**ZONING AMENDMENT,
PLANNED UNIT DEVELOPMENT &
SUBDIVISION STAFF REPORT**

Napolean McCovery

Napolean McCovery Subdivision

208 North Lafayette Street
(Southeast and Northeast corners of North Lafayette Street
and St. Stephens Road).

SITE PLAN

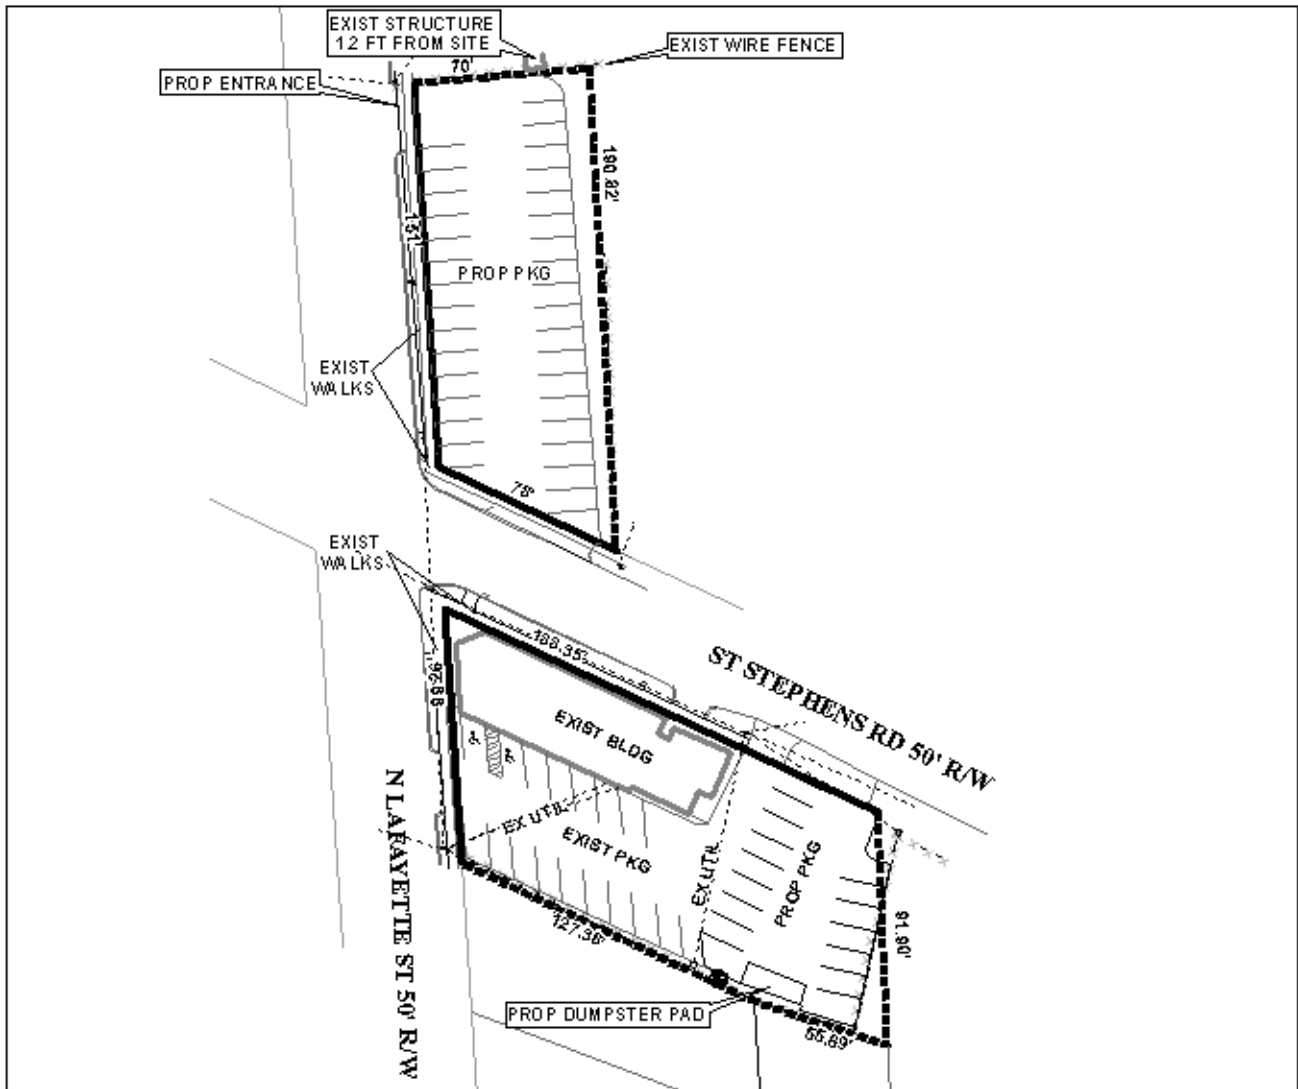
Driveway number, size, location, and design to be approved by Traffic Engineering and conform to AASHTO standards. Final approval for all driveways, proposed and existing will be given upon submittal of final plans. Unable to adequately review the site plans because a scale was not given on any of the submitted drawings. Plans also do not adequately depict driveway locations or details.

The “on premise” parking lot, which is adjacent to the existing lounge and parking, is partially zoned R-1, will contain 32 parking spaces, and will have one curb-cut onto North Lafayette Street. No buffer is shown along the Northern and Eastern boundaries of the parking lot site where it abuts R-1 zoned properties, as required by Section 64-4.D.1. of the Zoning Ordinance. Therefore, compliance with the buffering requirements of the Ordinance would be required.

The proposed “off-site” parking lot site plan depicts access onto both St. Stephens Road and North Lafayette Street; however, while encouraging access from a commercial parking lot onto a primarily residential street is not desirable, it would be preferable due to the status of St. Stephens as a major street. This proposed parking lot should be denied access to St. Stephens

Section 64-4.A.3.i. of the Zoning Ordinance requires that parking areas separated from an R-1 area (across North Lafayette Street) shall have a brick wall or evergreen hedge of a maximum height of three. The PUD and Zoning site plan should be revised to reflect this requirement. Additionally, section 64-4.A.3.c. of the Zoning Ordinance requires that parking areas with more than 10 spaces shall be illuminated during their operation, and that the lighting should be so arranged and directed that it does not shine directly into adjacent residences or the public right of way. Therefore, the revised plan(s) should also depict a lighting plan and clearly illustrate that the lighting will be shielding and directed to comply with section 64-4.A.3.c.

As commercial development, full compliance with the tree and landscaping requirements of the Zoning Ordinance will be required for both parking facility expansions. Existing trees on the site may reduce the number of new trees required, however, no calculations regarding required trees and tree credits have been provided. Detailed landscaping information will be required prior to the issuance of permits for construction.

The proposed “off-site” parking lot is currently unpaved and undeveloped. New construction will require compliance with the Engineering Department’s storm water and flood control regulations. Further, the expansion of the “on-site” parking lot may also require compliance with the Engineering Department’s storm water and flood control regulations. If a storm water detention facilities are required, the site plan should be revised accordingly.

Finally, given the fact that St. Stephens Road is a major street, and North Lafayette is a heavily travelled residential street, pedestrians should be directed to the St. Stephens Avenue/North Lafayette Street intersection to cross the street to the lounge, and a crosswalk provided for this function.

- 1) placement of a note on the site plan stating that PUD approval is site plan specific, and that any changes to the site plan, including the existing lounge, will require a new application to the Planning Commission;

- 2) revision of the site plan to depict parking area buffering in compliance with Section 64-4.A.3.i. of the Zoning Ordinance, where the proposed parking lot abuts or is across the street from residential zoning districts;

- 3) revision of the site plan to place the requirements of Section 64-6.A.3.c., *Lighting*, as a note on the site plan: *"If parking areas contain ten (10) or more cars, lighting shall be provided and maintained during their operation, and shall be so arranged that the source of light does not shine directly into adjacent residential properties or into traffic."*

- 4) revision of the site plan to depict full compliance with the landscaping and tree requirements of the Zoning Ordinance for the proposed parking areas;

- 5) revision of the site plan to depict a storm water detention area for the proposed parking area, if required;
- 6) revision of the site plan to direct pedestrian traffic from the proposed parking area to the intersection of St. Stephens Road/North Lafayette Street intersection for street crossing to the lounge, and installation of necessary improvements such as a crosswalk;

- 7) provision of a revised PUD site plan (and parking area specific site plan) to the Planning Section of Urban Development prior to the signing of the final subdivision plat; and
